JLRTB02149NAS2

TECHNICAL BULLETIN

Fuel Vapor Smell in Passenger Compartment - Further Enhancements

MODEL:	MODEL YEAR:	ASSEMBLY PLANT:	APPLICABILITY:
Range Rover (LK)	2022 Onwards	Solihull	INGENIUM I6 3.0L Petrol/V8 T/C 4.4L Petrol
Range Rover Sport (L1)	2023 Onwards	Solihull	INGENIUM I6 3.0L Petrol/V8 T/C 4.4L Petrol

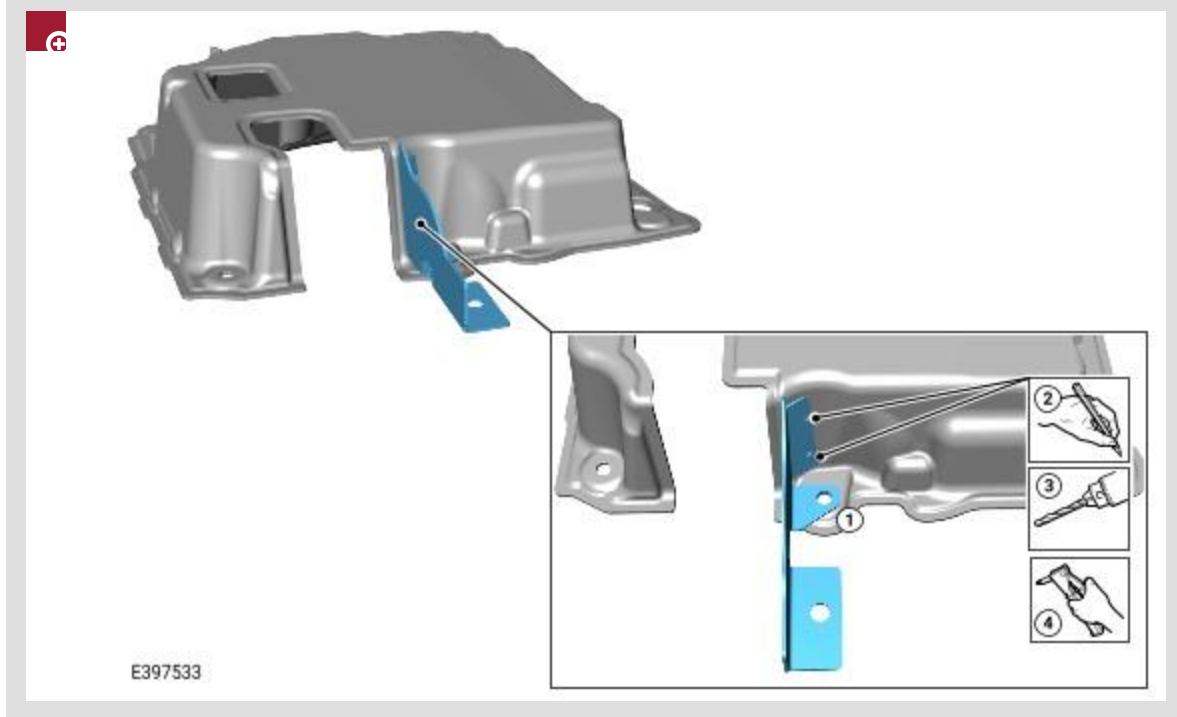
Install the lower startup battery housing NVH inner deflector.

The bottom of the deflector must be flush with the rim of the upper startup battery housing NVH.

Position the deflector to the measurement shown in the illustration.

2. Mark the holes with a suitable marker.
3. Drill the holes using a 5 mm drill bit.

Secure the deflector with suitable 5 mm rivets.

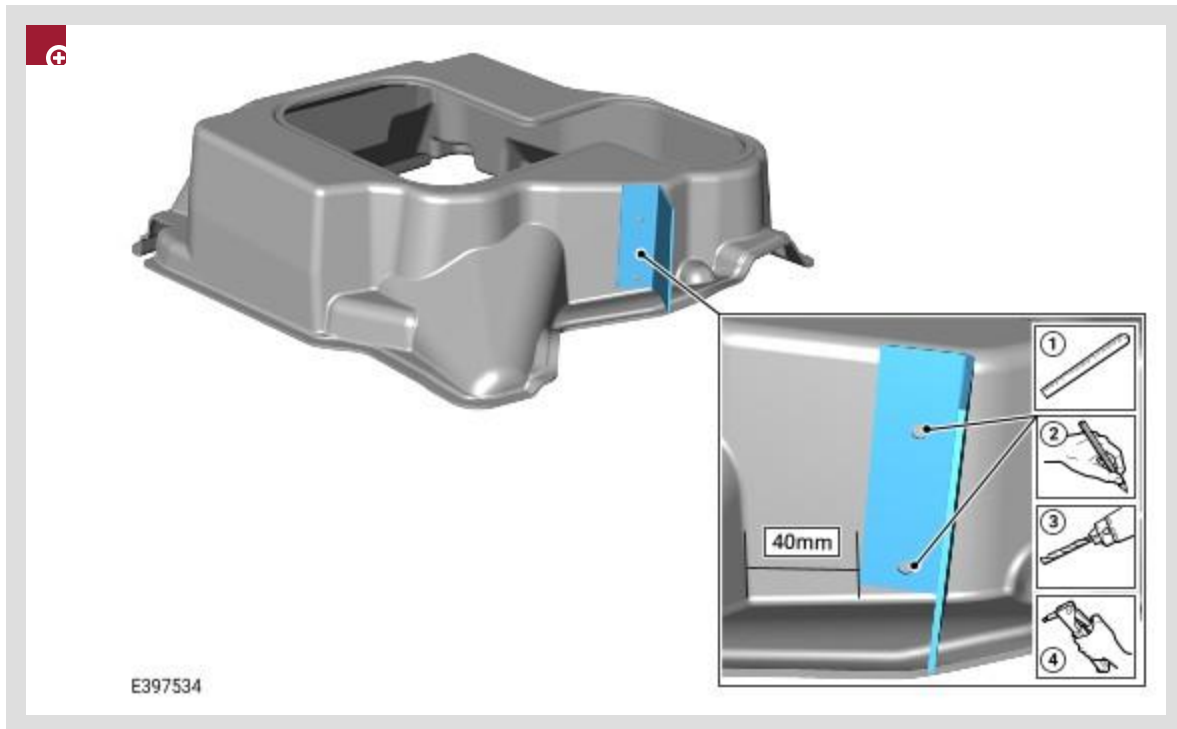
Install the lower startup battery housing NVH outer deflector.

The bottom of the deflector must be flush with the rim of the lower startup battery housing NVH.

Align the deflector with the hole in the upper startup battery housing NVH, as shown in the illustration.

3. Drill the holes using a 5 mm drill bit.

Secure the deflector with suitable 5 mm rivets.

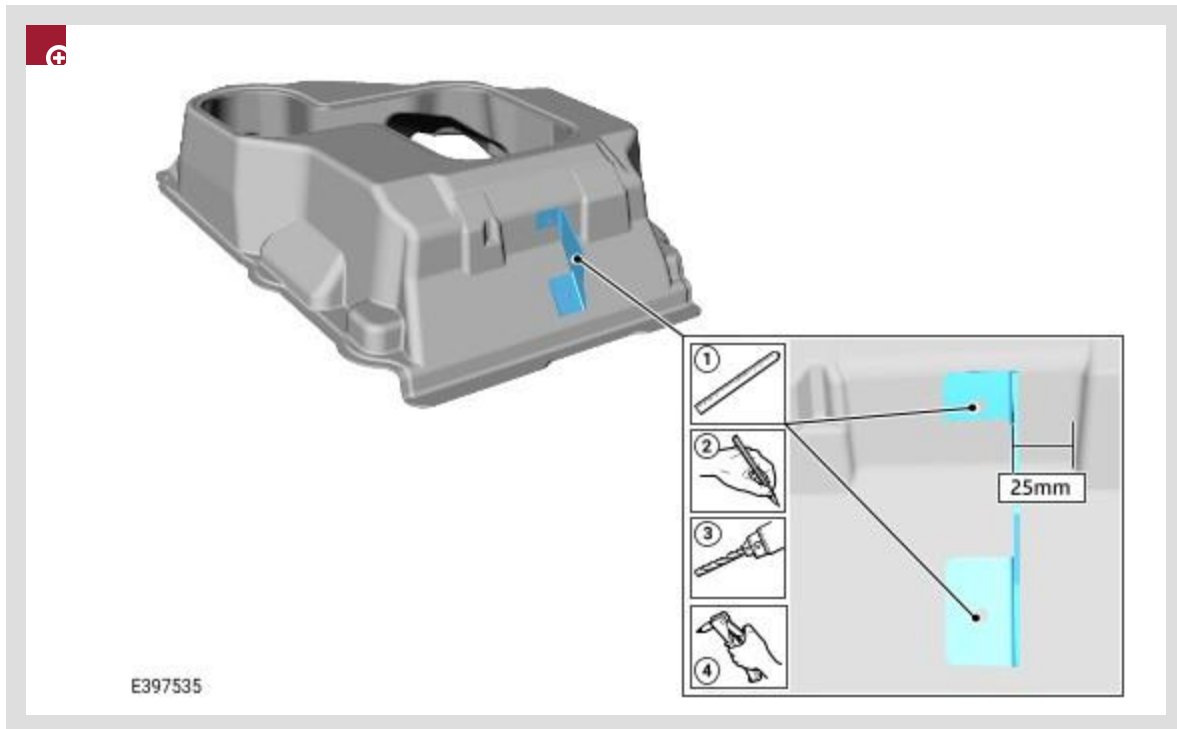
Install the upper startup battery housing NVH inner deflector.

The bottom of the deflector must be flush with the rim of the lower startup battery housing NVH.

Position the deflector as per the measurement in the illustration.

2. Mark the holes with a suitable marker.
3. Drill the holes using a 5 mm drill bit.

Secure the deflector with suitable 5 mm rivets.

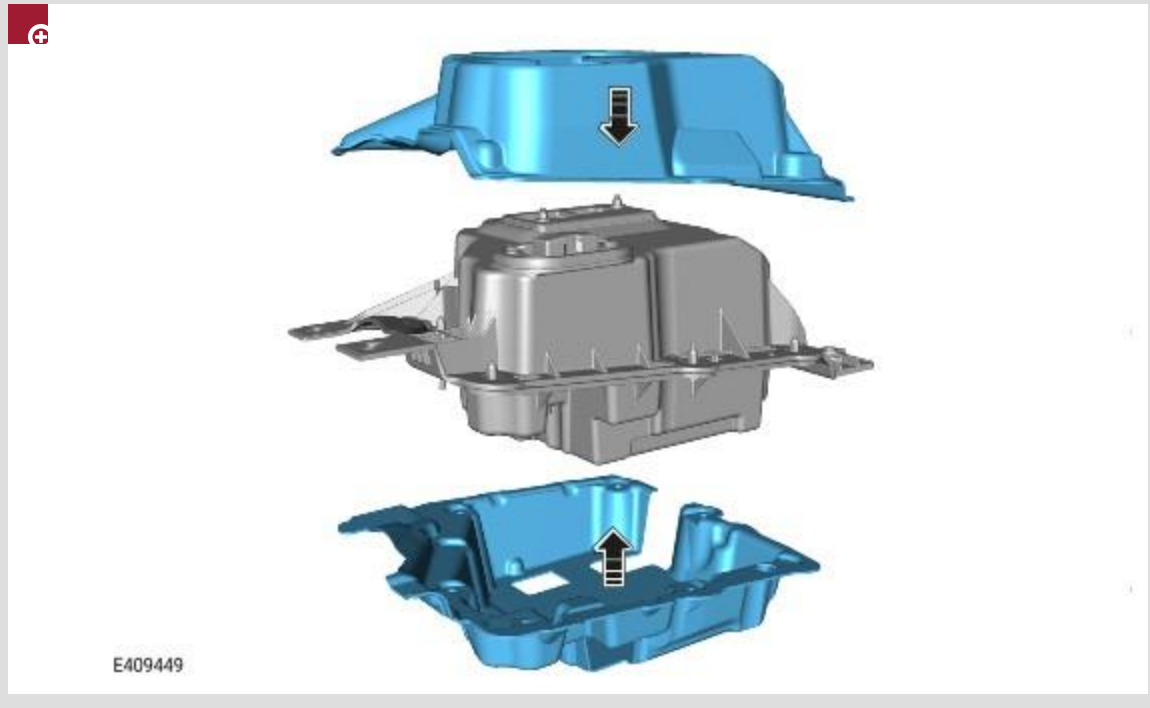
Install the upper startup battery housing NVH outer deflector.

The bottom of the deflector must be flush with the rim of the lower startup battery housing NVH.

Position the deflector as per the measurement in the illustration.

3. Drill the holes using a 5 mm drill bit.

Secure the deflector with suitable 5 mm rivets.

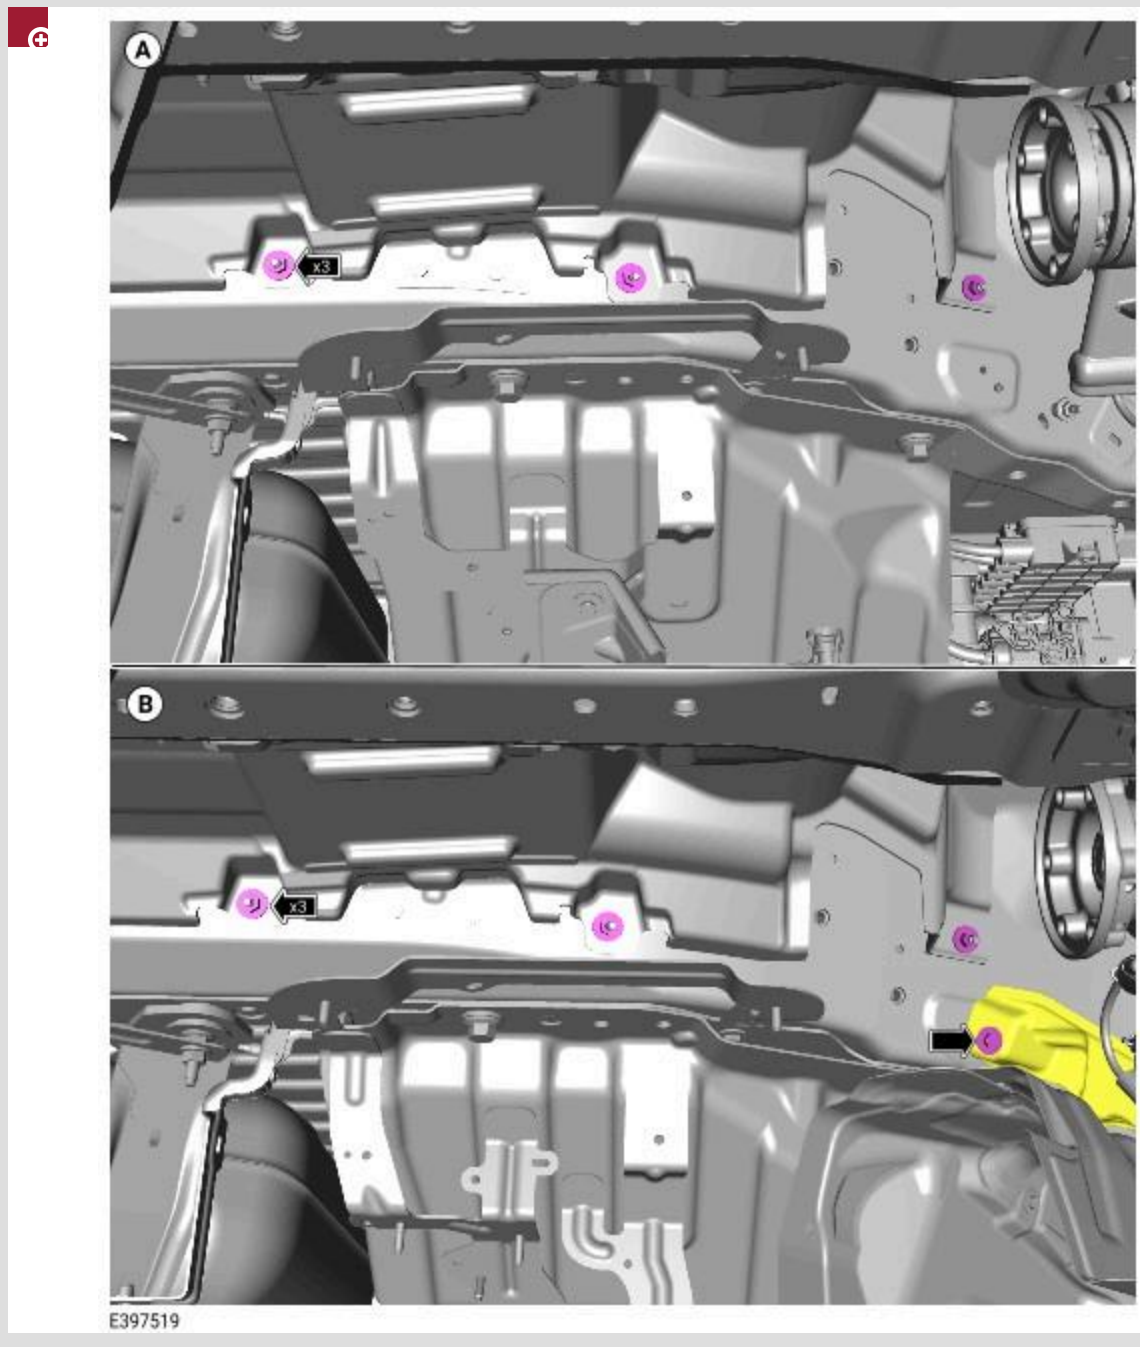
Position the rear driveshaft heatshield as shown in the illustration.

- Temporarily secure the heatshield by installing a nut removed previously, but do not tighten.

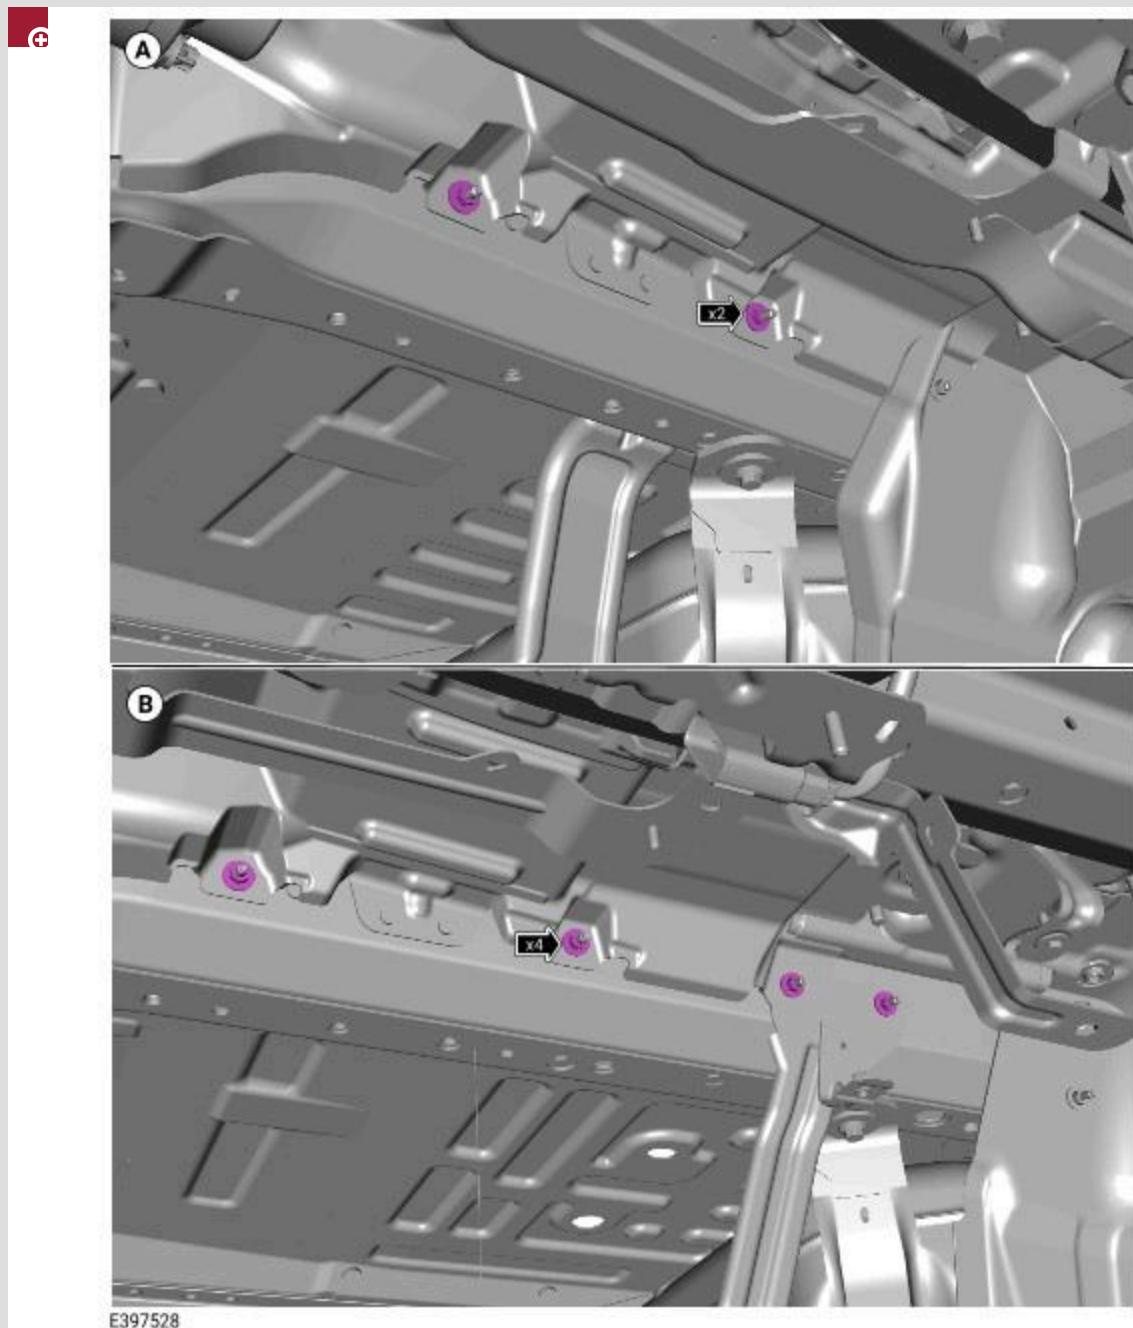
- **(A) SWB vehicles** - Install the new fuel tank heatshield.
 - Secure the new fuel tank heatshield onto the 4 studs.
 - Torque: **5Nm**
 - Install 5 new bolts (AYP500110).
 - Torque: **5Nm**
 - Install the 3 nuts previously removed.
 - Torque: **5Nm**

- **(B) LWB vehicles** - Install the new fuel tank heatshield.
 - Secure the new fuel tank heatshield onto the 4 studs.
 - Torque: **5Nm**
 - Install 5 new bolts (AYP500110).
 - Torque: **5Nm**
 - Install the 2 nuts previously removed.
 - Torque: **5Nm**
 - Install 1 new nut (RYH500310).
 - Torque: **5Nm**

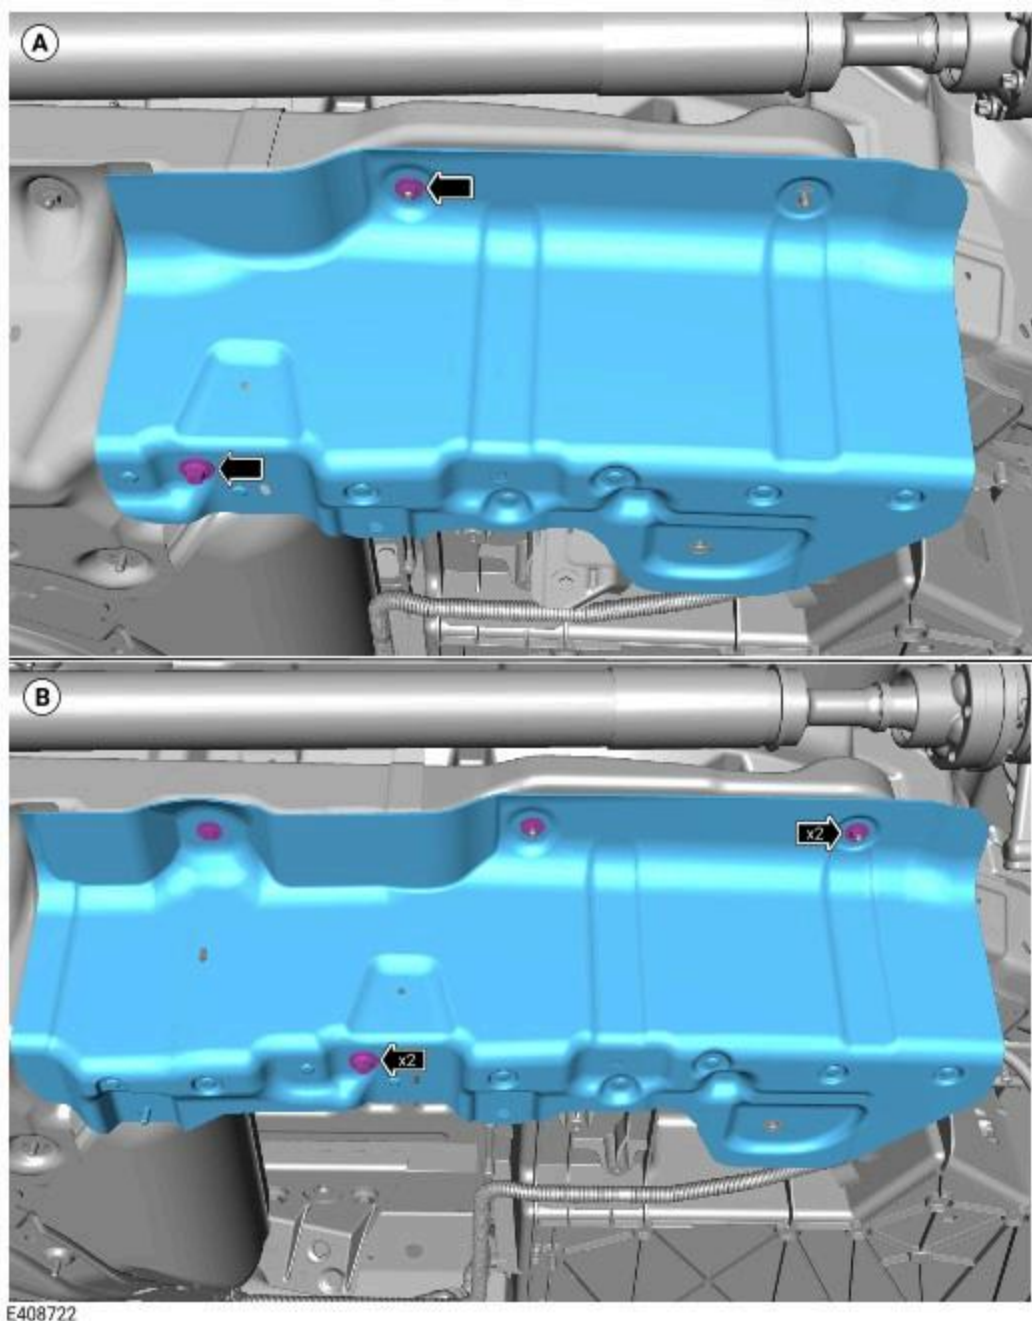
- **(A) SWB vehicles** - Install the new right heatshield.
 - Install the 2 nuts previously removed.
 - Torque: **5Nm**
 - Install the 2 bolts previously removed.
 - Torque: **5Nm**
- **(B) LWB vehicles** - Install the new right heatshield.
 - Install the 4 nuts previously removed.

- Torque: **5Nm**
- Install the 3 bolts previously removed.
 - Torque: **5Nm**

E408722

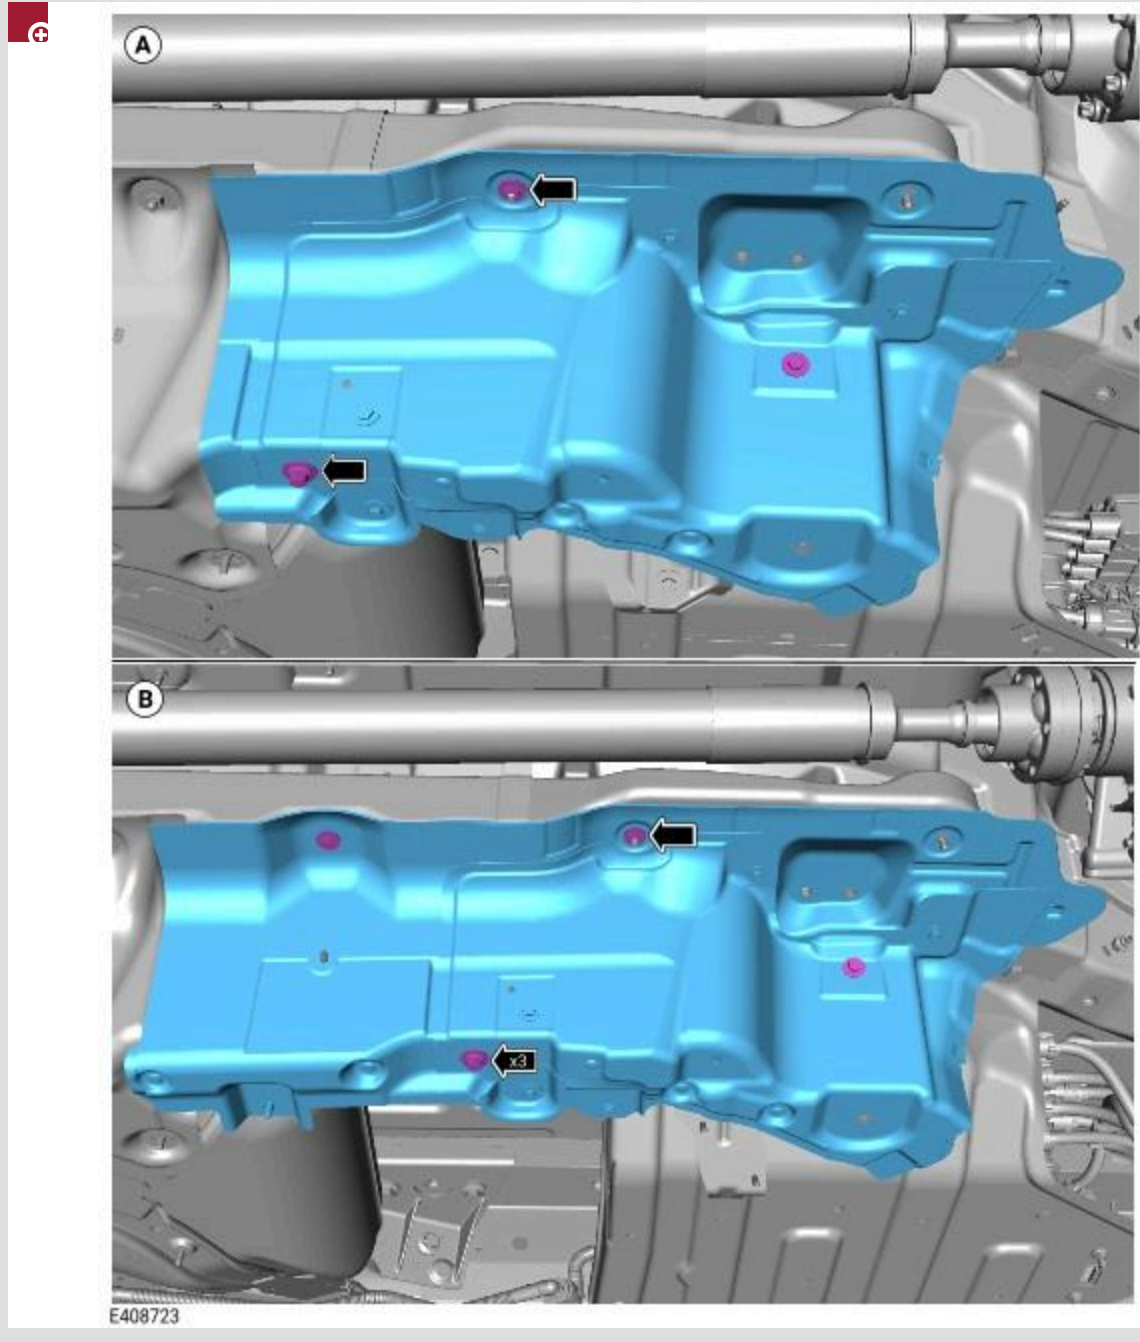
- **(A) SWB INGENIUM I6 3.0L Petrol vehicles to the end of 2024 model year -**
Install the new left heatshield.
 - Install the nut previously removed.
 - Torque: **5Nm**
 - Install the bolt previously removed.
 - Torque: **5Nm**

- **(B) LWB INGENIUM I6 3.0L Petrol vehicles to the end of 2024 model year -**

Install the new left heatshield.

- Install the 2 nuts previously removed.
 - Torque: **5Nm**
- Install the 2 bolts previously removed.
 - Torque: **5Nm**
